North Westerly - PD 2nd Review

To: John Prestwich, PCS Group
From: Aly Burkhalter, Senior Planner
Date: August 16, 2024
Re: PD-001700-2024 North Westerly - PD

2nd Review & Referral Comments

CONCEPT PLAN

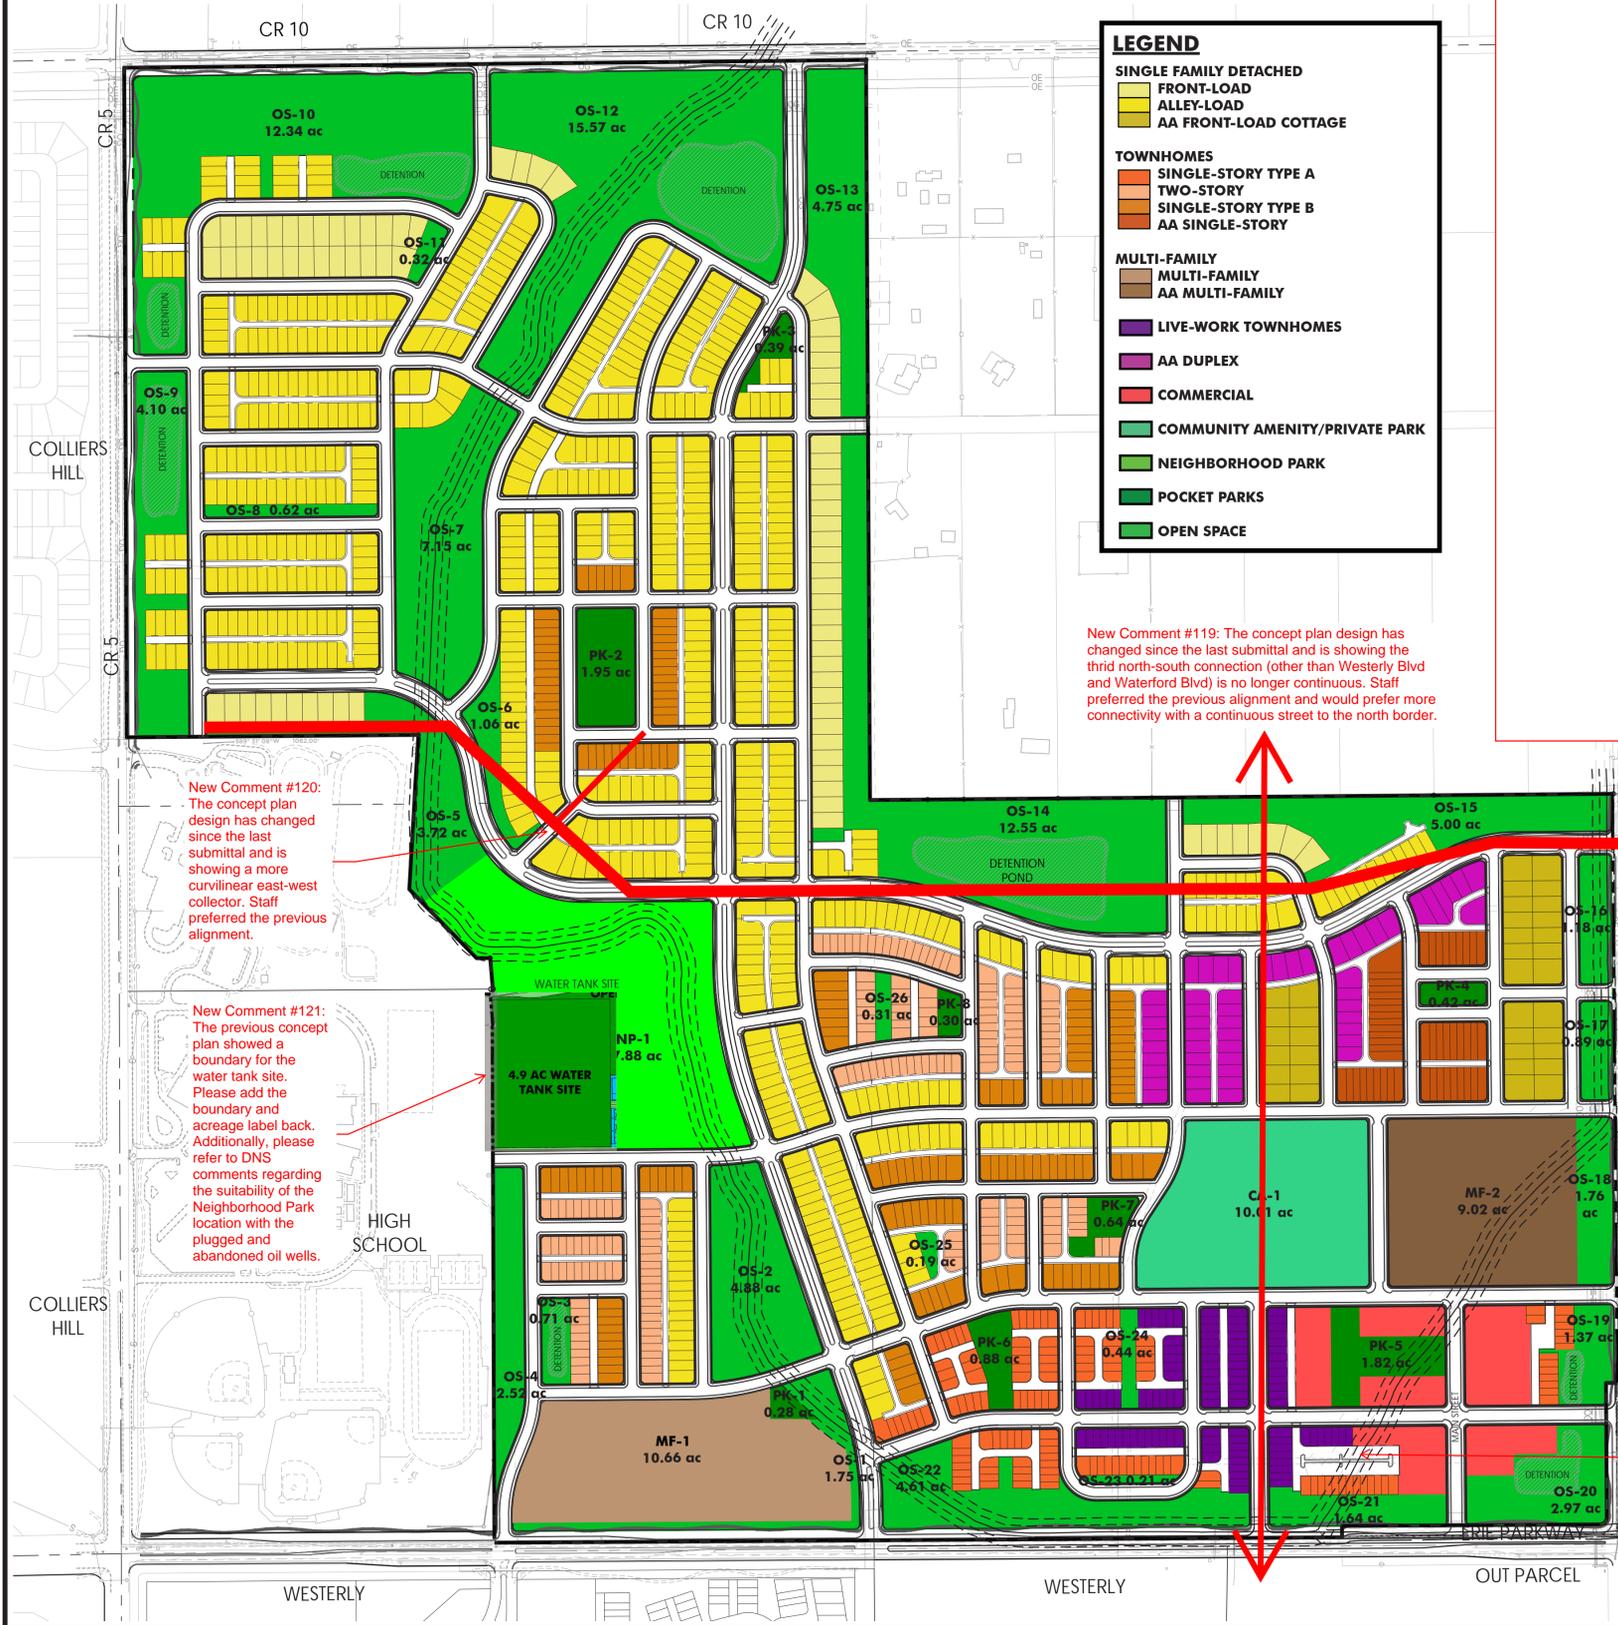
Comment #117c: Concept Plan sheet graphic to remain as-is with Land Use Summary chart added to sheet and Dimensional Standard sheet moved to same sheet as Parking Requirements.

**COMMERCIAL
DEVELOPMENT
STANDARDS**

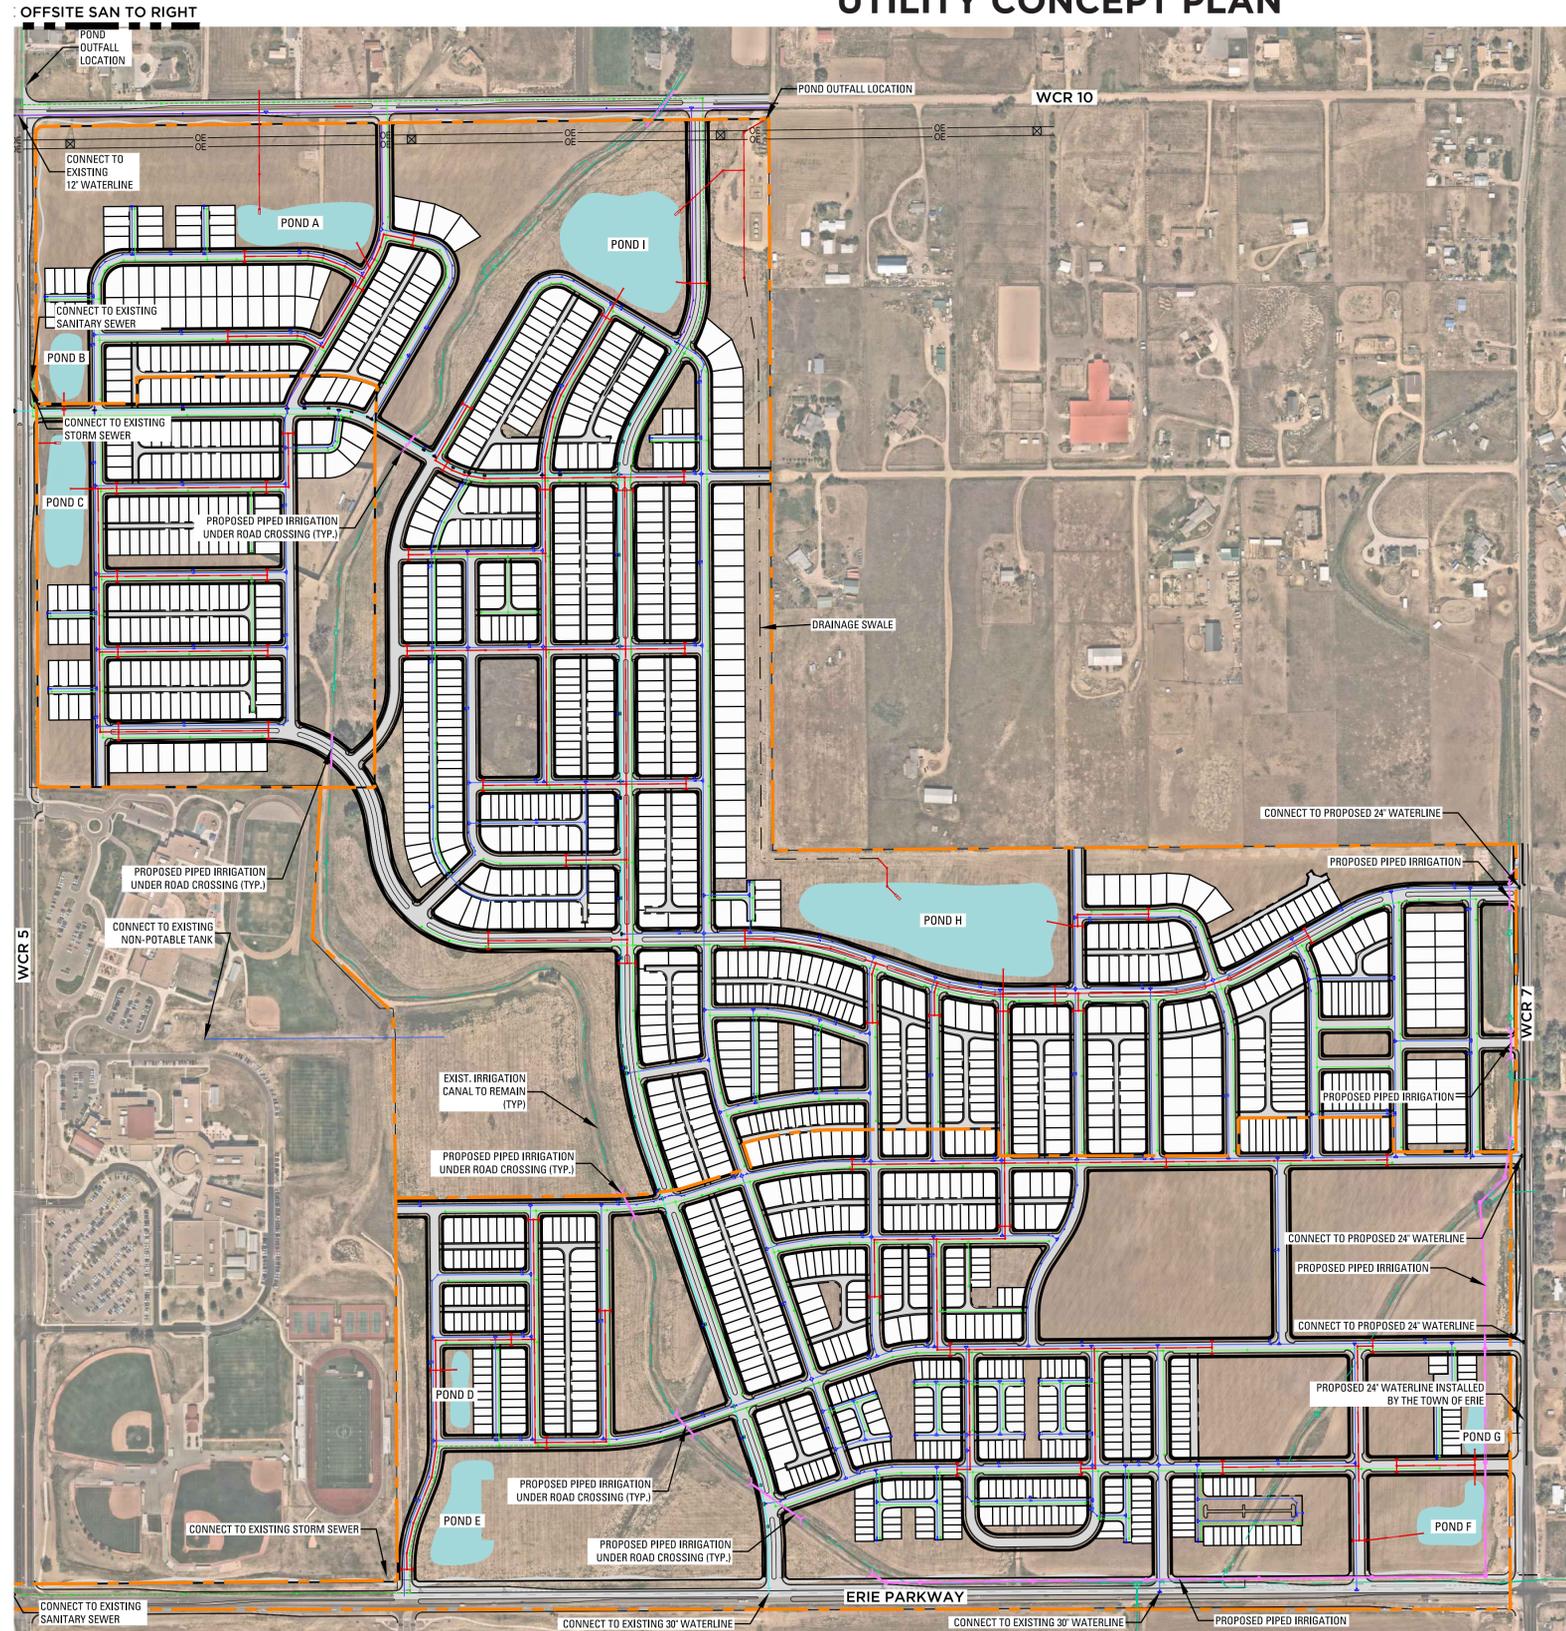
Comment #66: Copy example disclaimer from sheet 9 to sheet 10 to accompany the additional photos: "WE ARE PROVIDING THIS EXAMPLE OF HOW A DRIVE THROUGH FOR A BANK HAS BEEN SUCCESSFULLY INTEGRATED INTO THE PEDESTRIAN COMMERCIAL MIXED USE ENVIRONMENT IN SOUTHERN LANDS WESTHAVEN COMMUNITY"

UTILITY CONCEPT PLAN

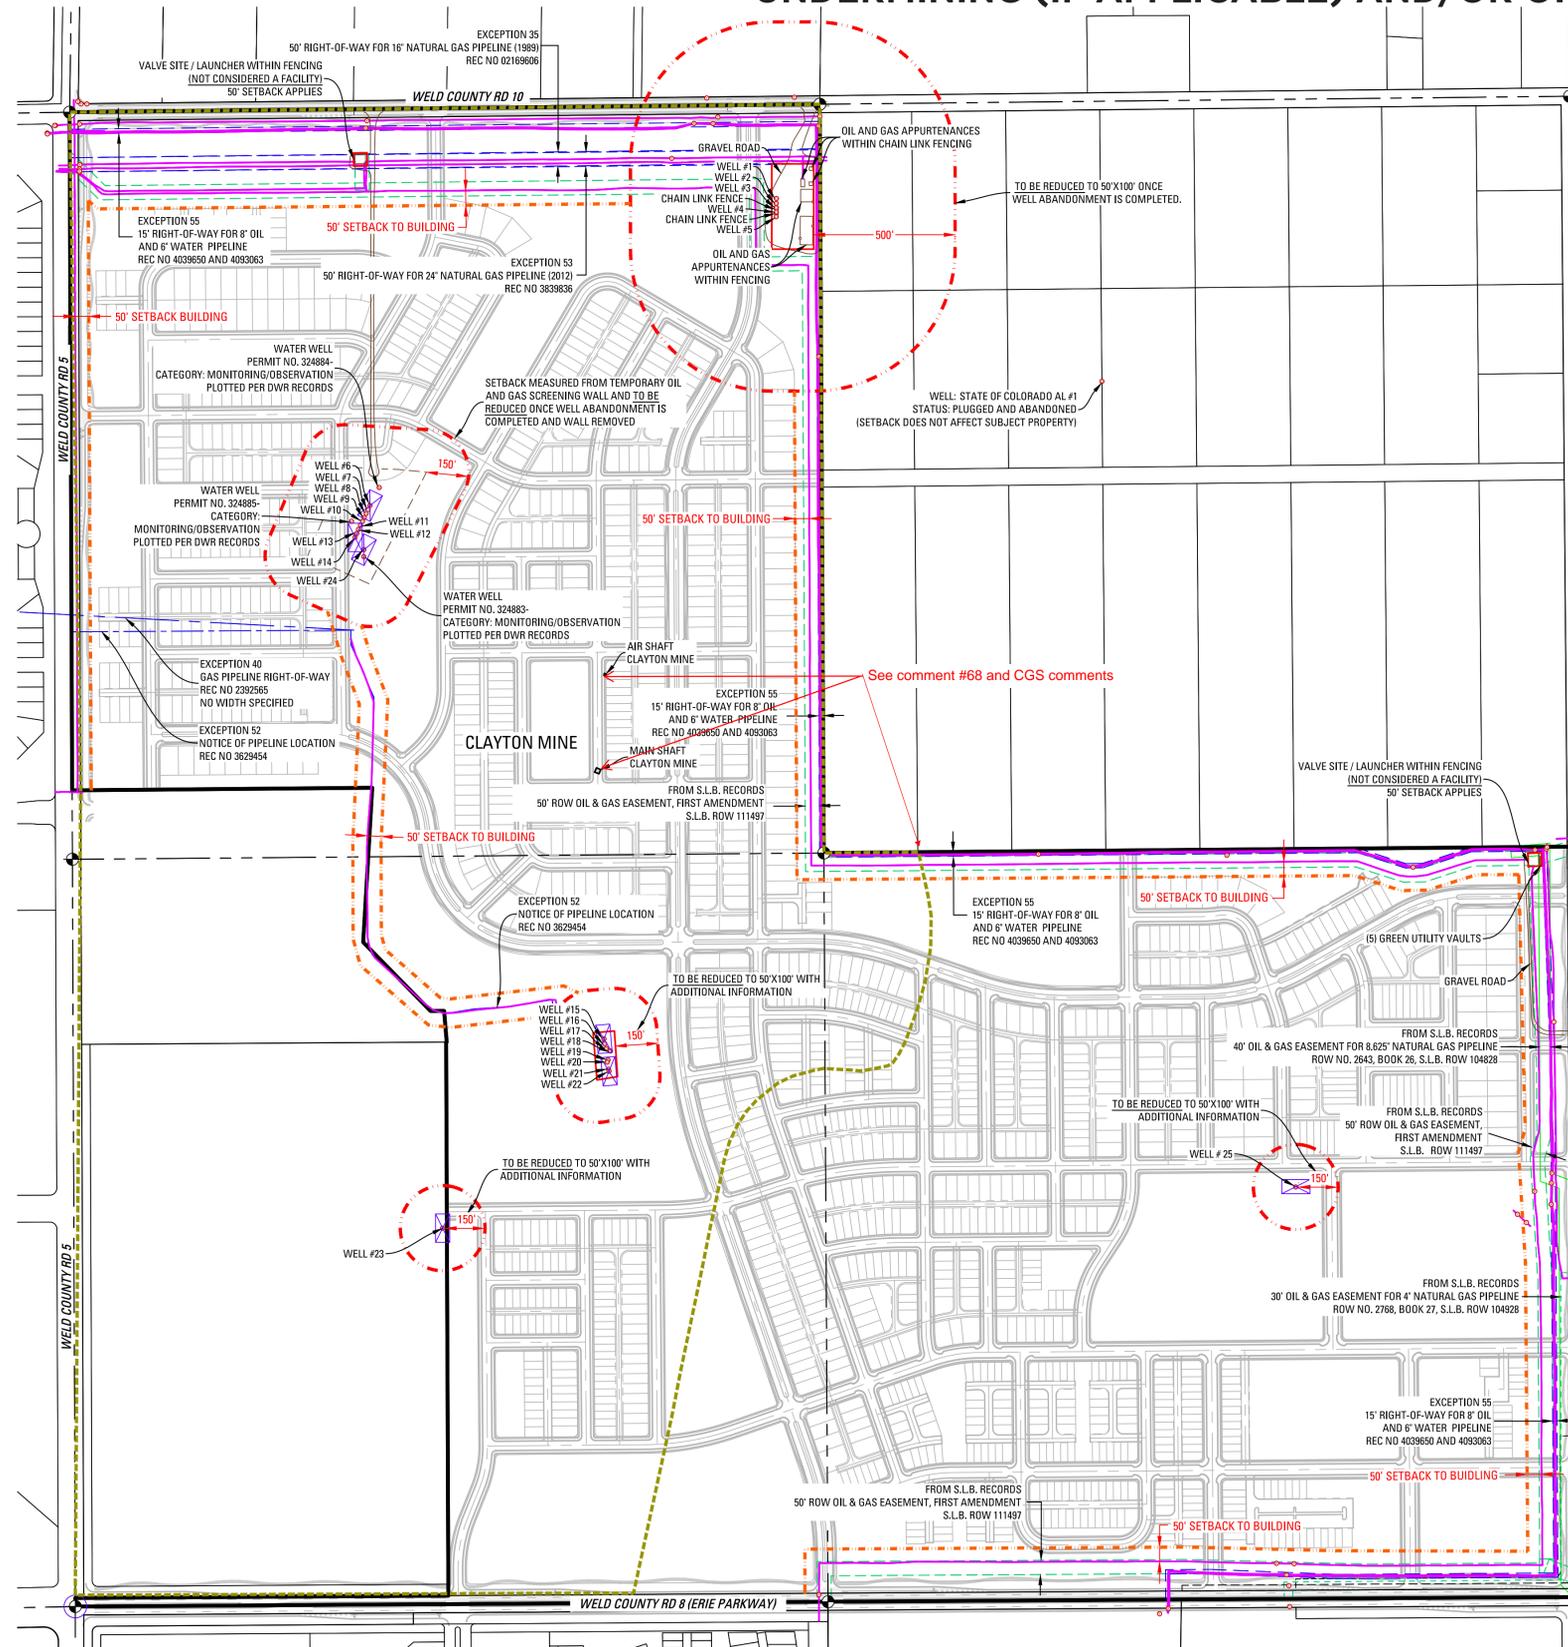
6. We have the following comments on Sheet 12, Utility Concept Plan:
- a. Show the existing utilities.
 - b. The portion of Pond C labeled as Pond E on the Utility Concept Plan (Sheet 12), is not shown on the Concept Plan (Sheet 4). Revise the Concept Plan to show Pond E to match.

UNDERMINING/
OIL & GAS PLAN

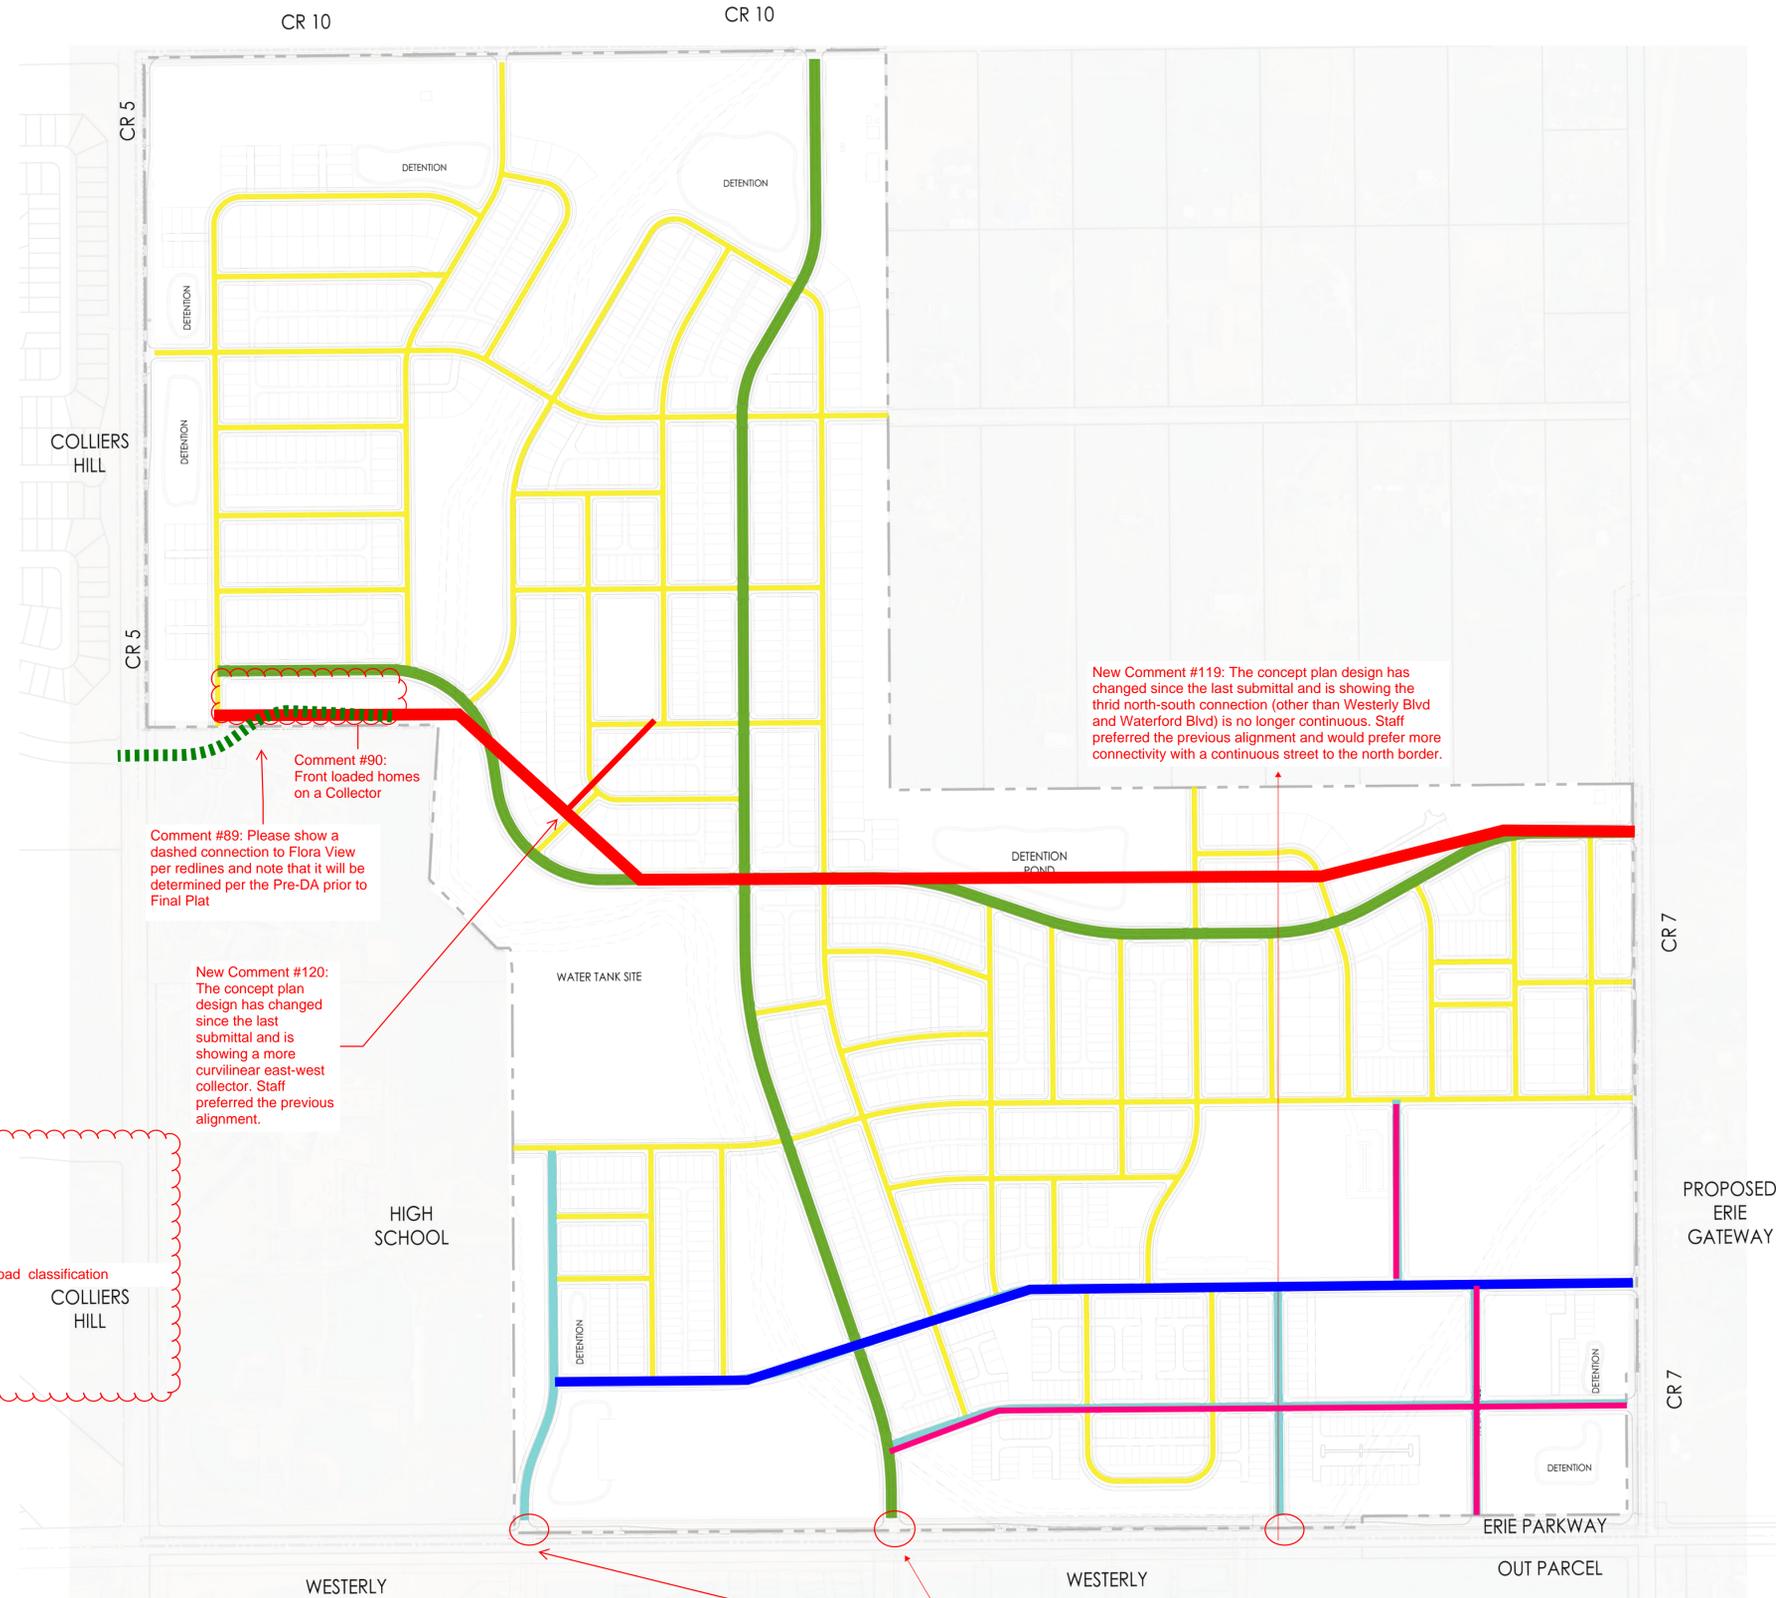
111. It is indicated in the Mine Subsidence Report that buildings should be limited to less than 165-ft and two-stories or less in the Subsidence Zone A. It is unclear where this area is indicated on Undermining Plan (Sheet 13 of the PD Zone Map and Guide). Additionally no structures should be located within 25-ft of the capped shafts of the Clayton Mine which was not clearly demarcated on the Undermining Plan. Applicant RESPONSE: An updated subsidence report has been included with this submittal. Town Response: Resolved. Please see comments #68 and #69 above.
